Tribander RevA.1 Addendum

On our Tribander kits with a RevA.1 circuit board, there is a small modification that is needed in order for the audio chain to work correctly.

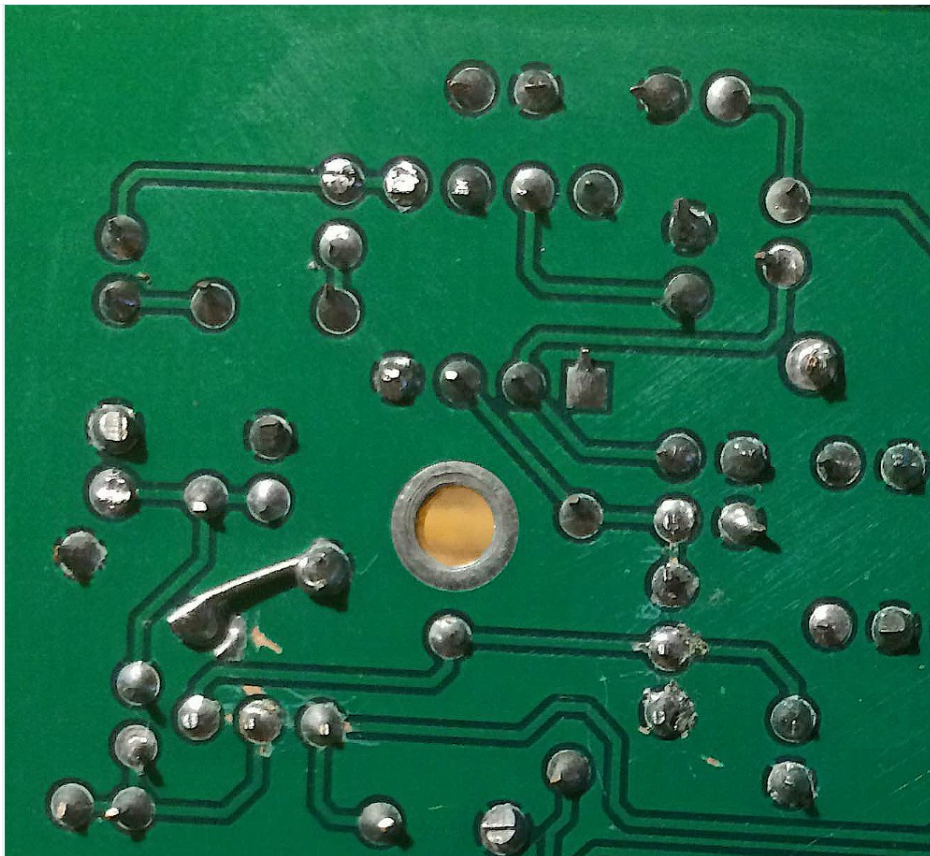
One pad of R18 located in the lower left quadrant of the board just adjacent to Q9 was left ungrounded and needs to be connected to ground. This pad also has a trace right next to it but is not connected to the trace.

This the leftmost pad of R18as you look at the board from the top with the front side toward you.

Our recommended way to accomplish this is to add a wire between the unconnected pad of R18 and the adjacent, grounded pad of R25 as shown in the photo below. As these pads are grounded anyway, the wire does not need to be insulated from the surrounding groundplane.

The easiest way is just use the excess lead from either R18 or R25 and bend it over to reach the other pad. The photo below shows the location of the wire.
